CONSTRUCTION DOCUMENTS FOR:
HAVEN VALLEY
 (LETA DR.) BRADLEY RD/ALTURAS DR.
 SECURITY, EL PASO COUNTY, COLORADO

v1_Construction Drawings.pdf Markup Summary 10-19-2023

**STORM SEWER
 OUTFALL
 PLAN & PROFILE**

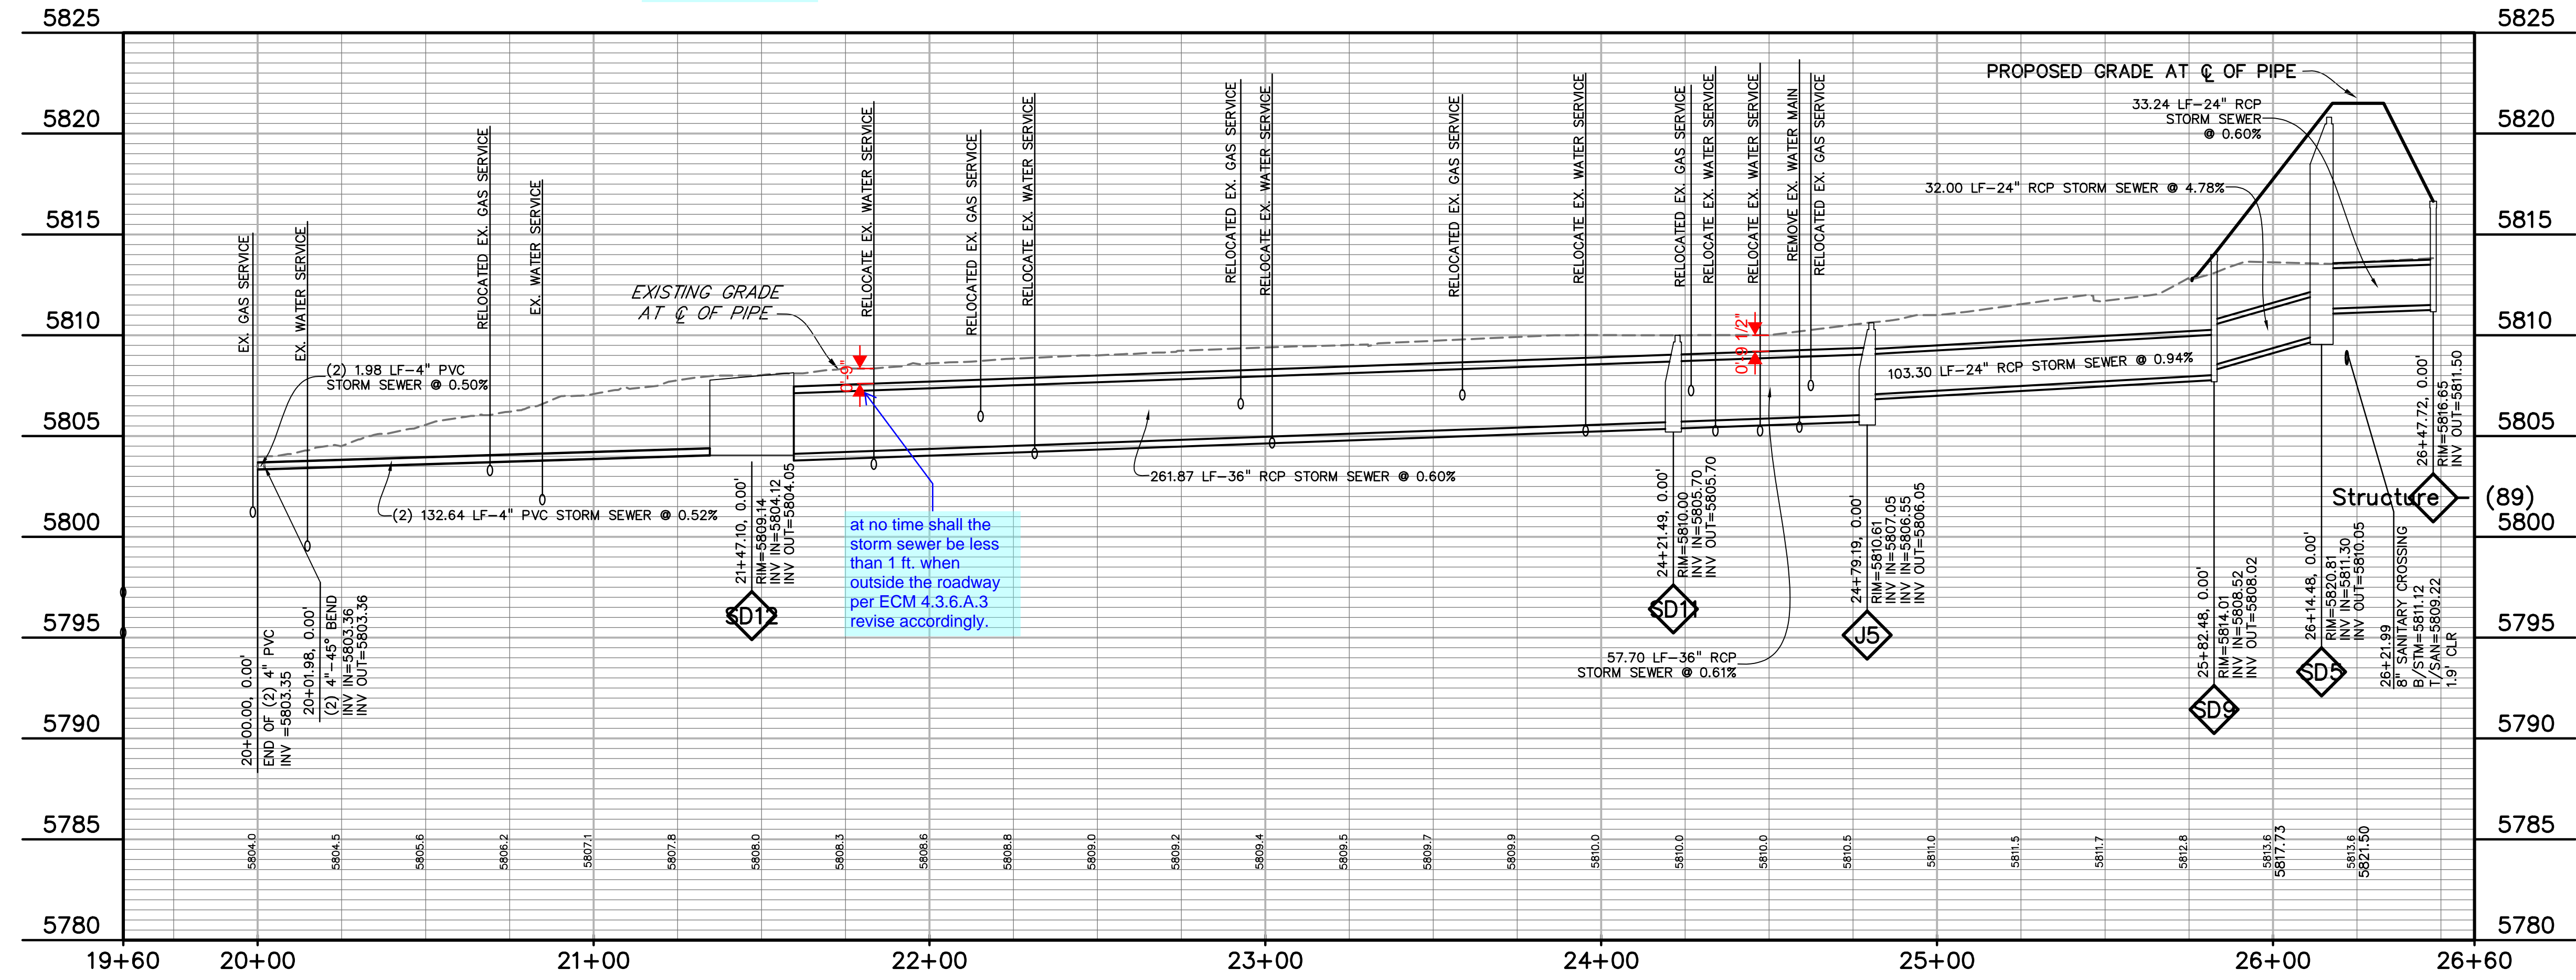
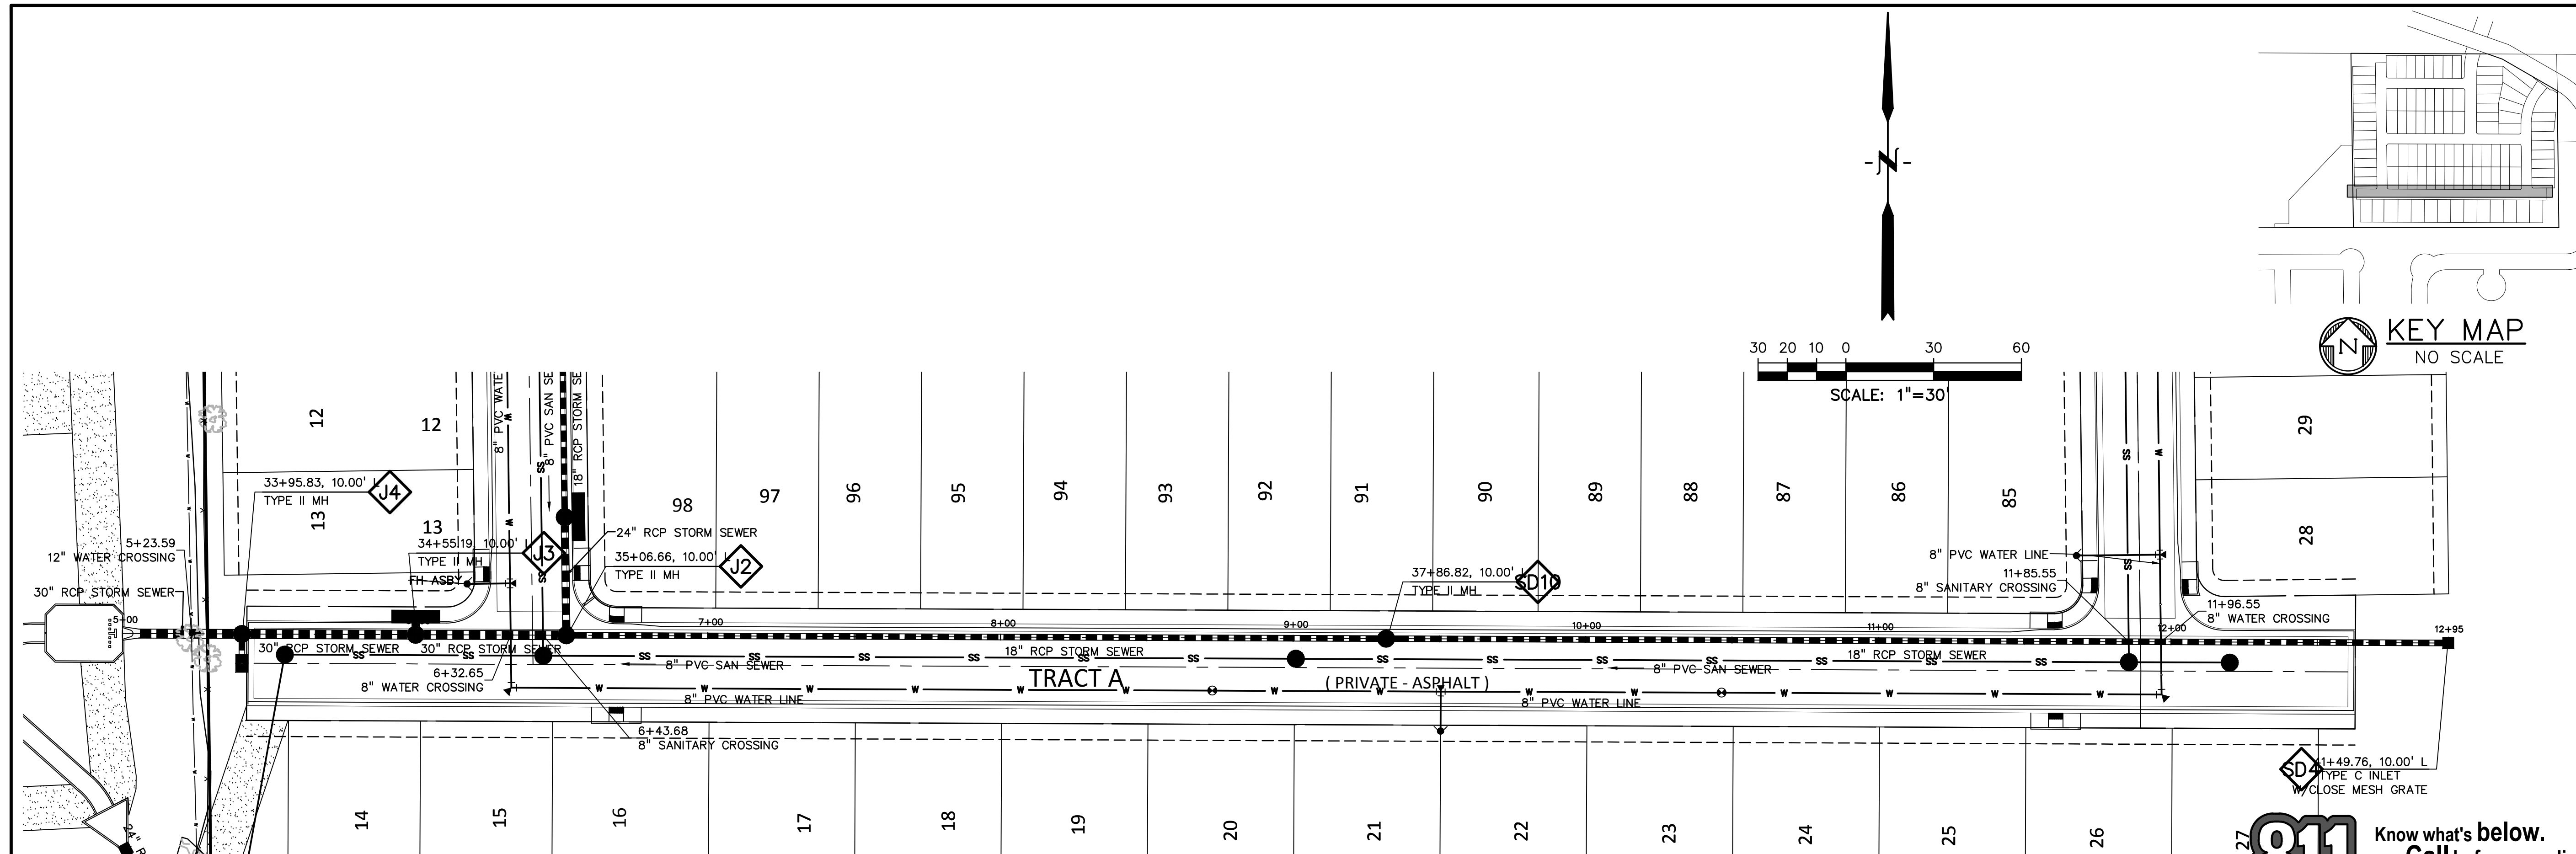
provide detail for gas relocation

add whichever is greater

fix overlapping text

Provide detail concrete wall proposed at the spillway

revise per comments on the drainage report

at no time shall the storm sewer be less than 1 ft. when outside the roadway per ECM 4.3.6.A.3 revise accordingly.

STORM SEWER PLAN & PROFILE
PROJECT NO. 21085-03CSCV
DRAWING NO.

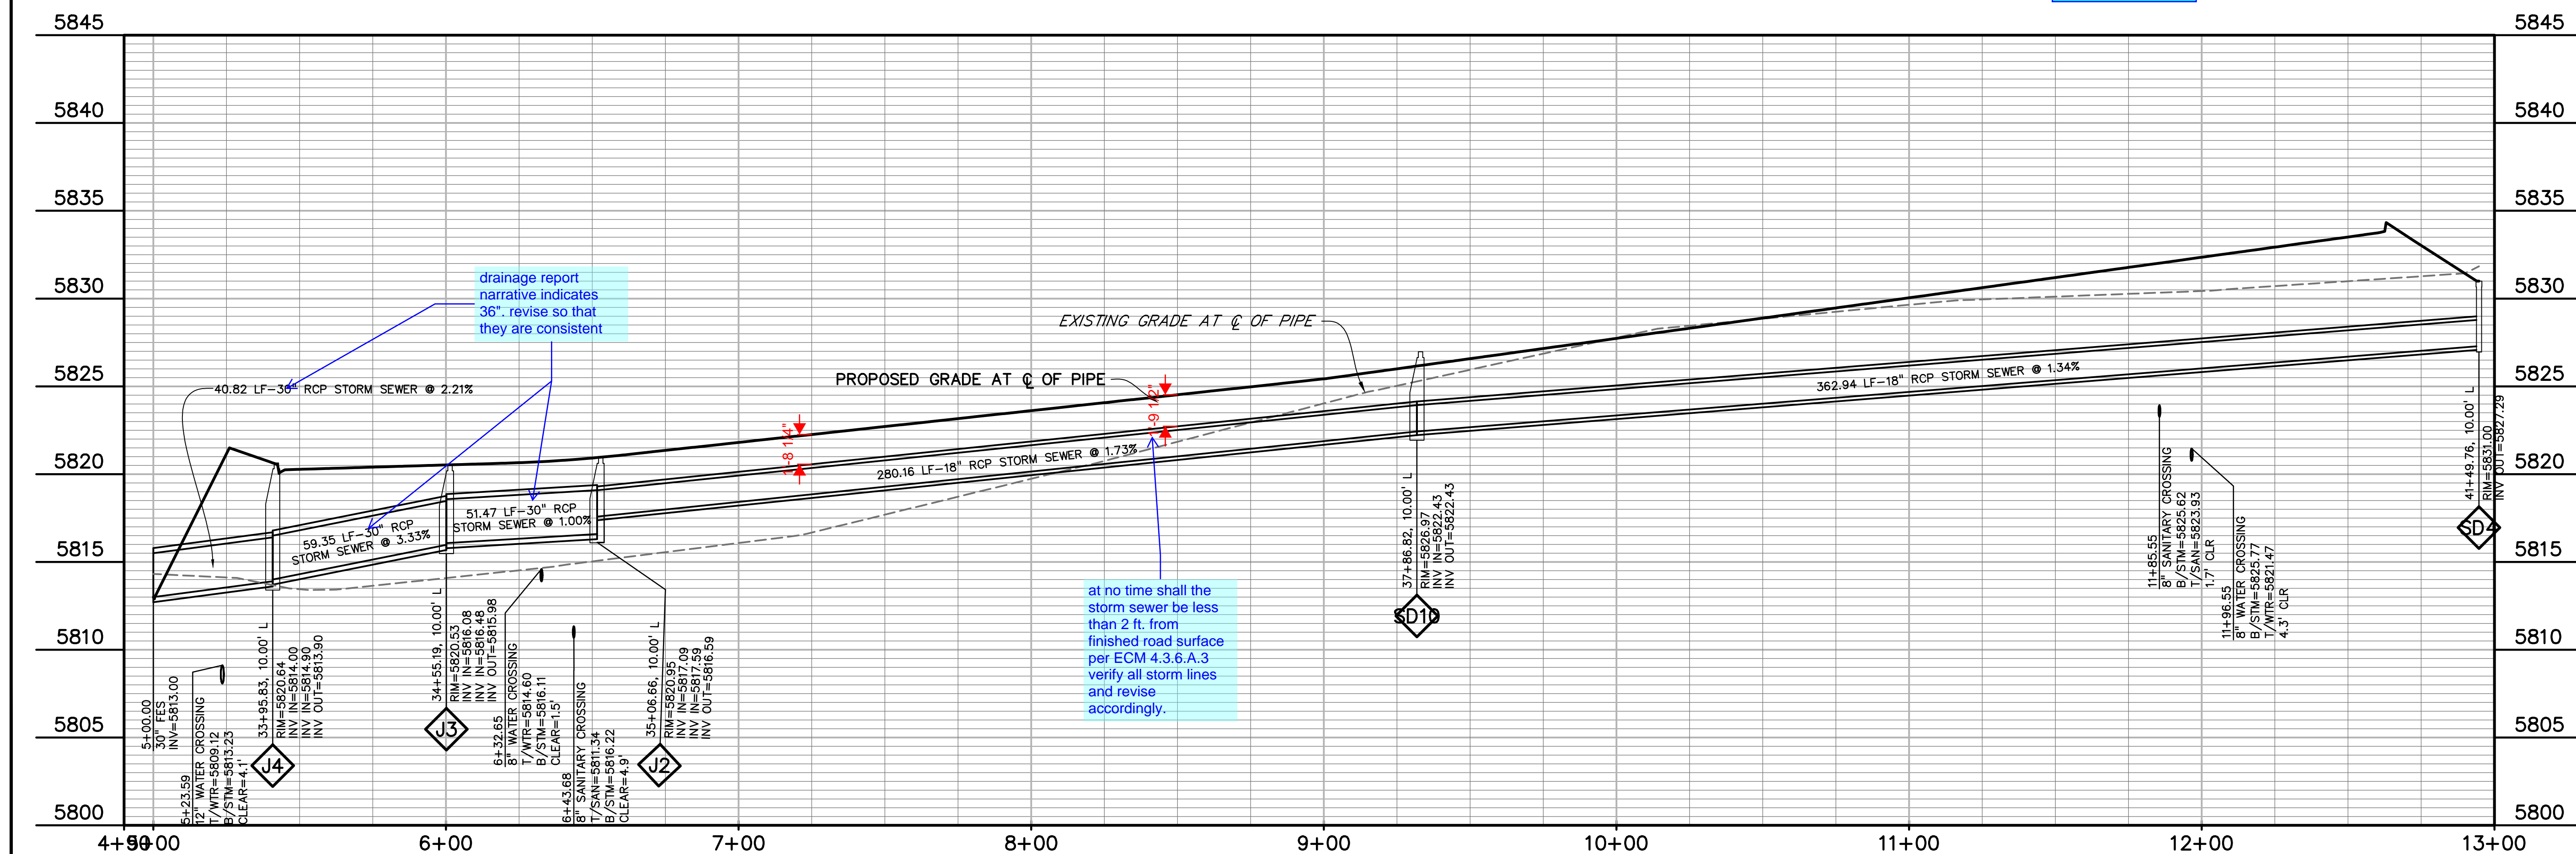
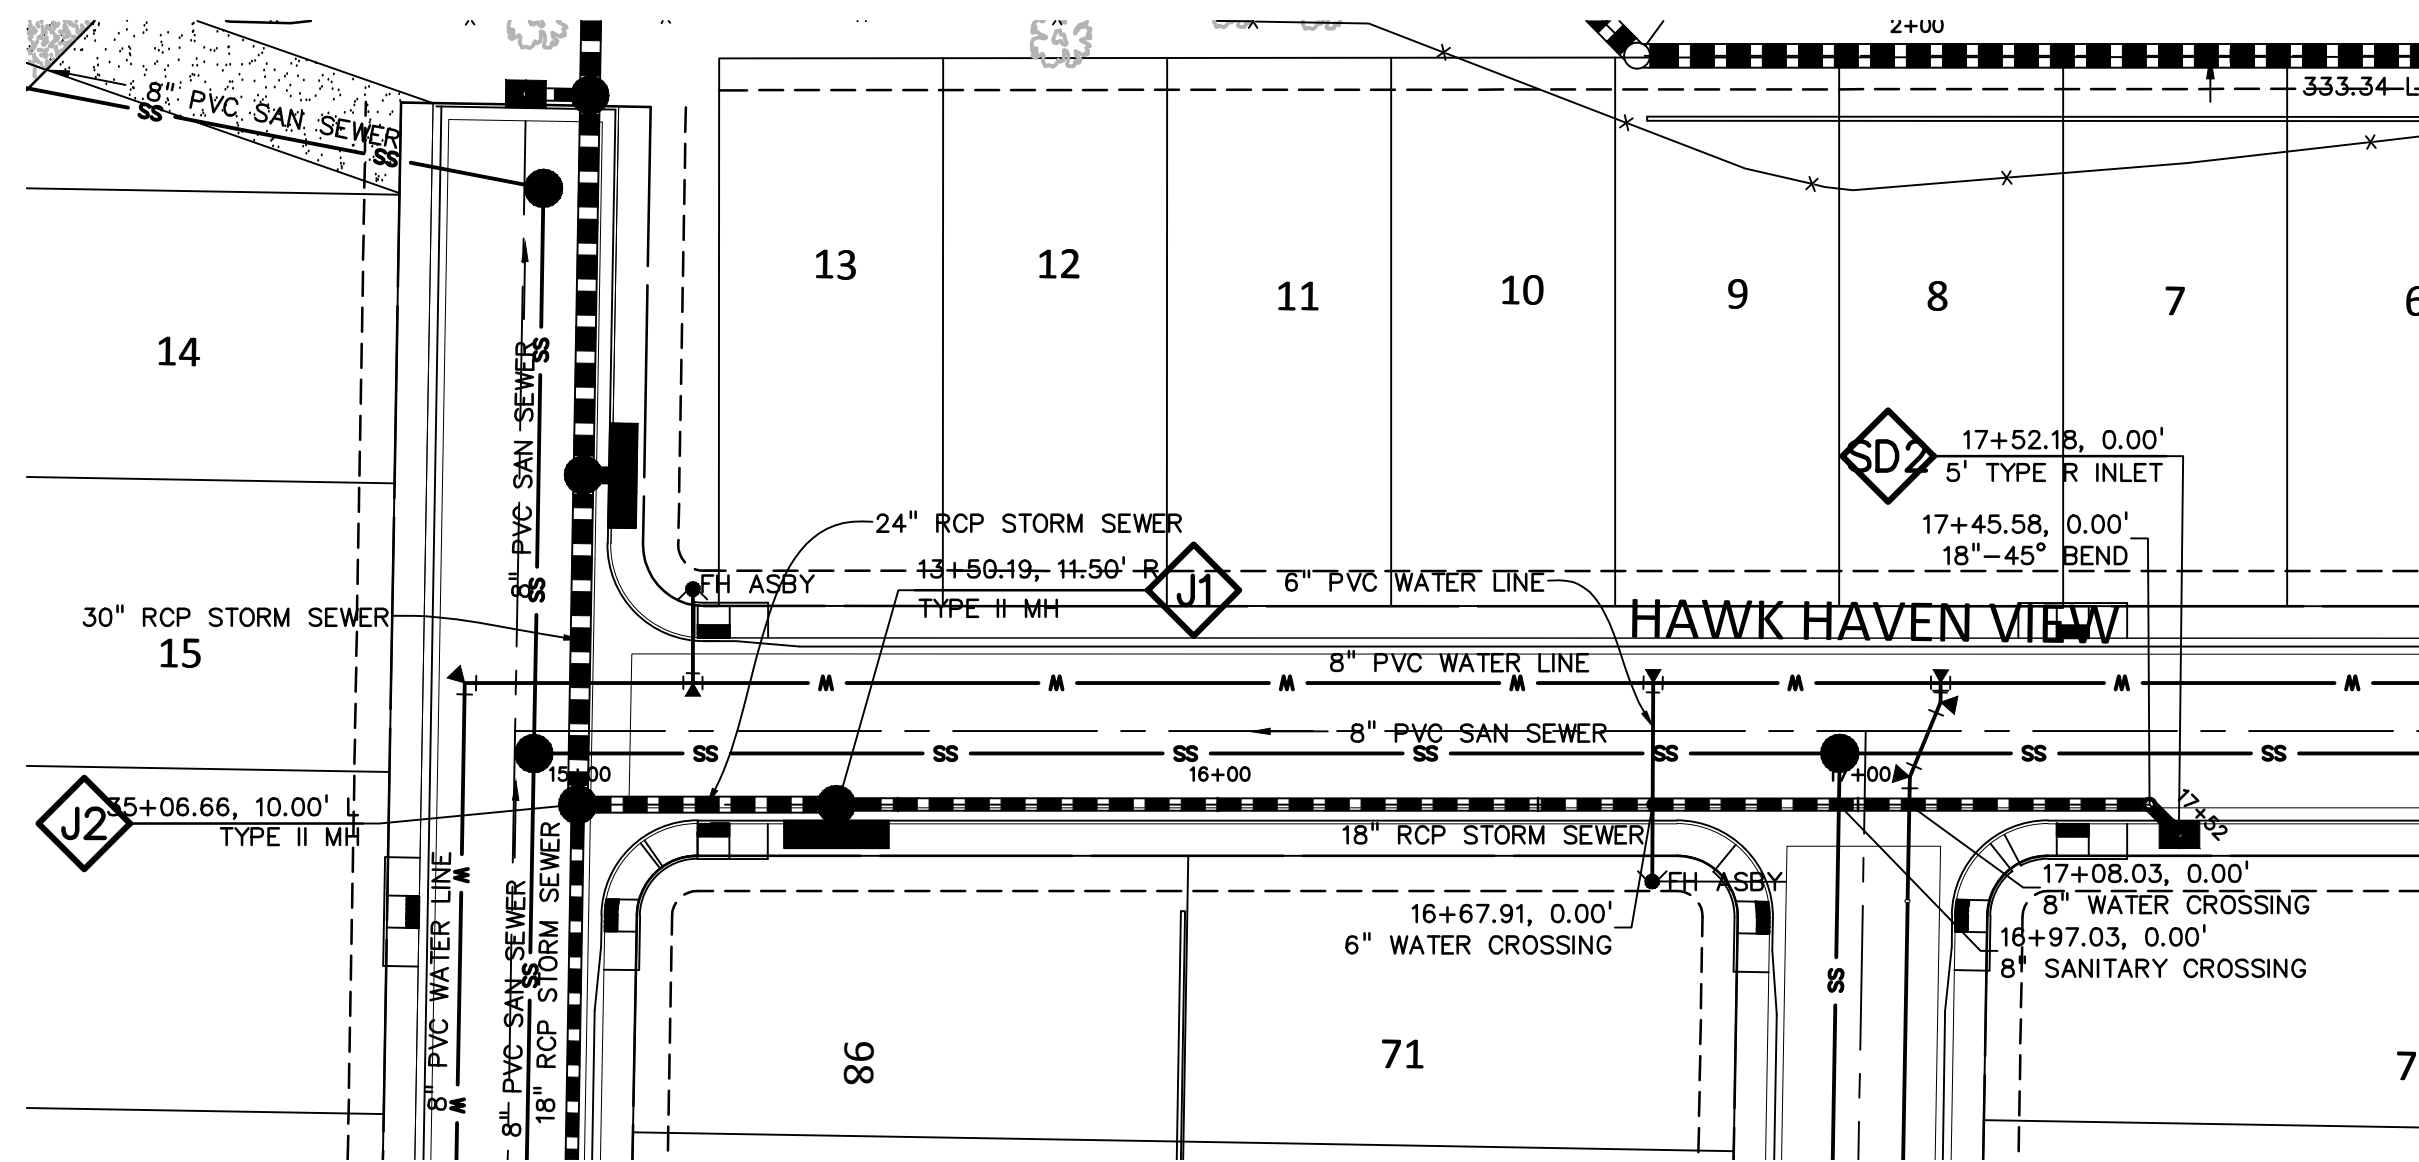
Revise all storm profiles to show hydraulic and energy grade line.

at no time shall the storm sewer be less than 2 ft. from finished road surface per ECM 4.3.6.A.3 verify all storm lines and revise accordingly.

drainage report narrative indicates 36". revise so that they are consistent
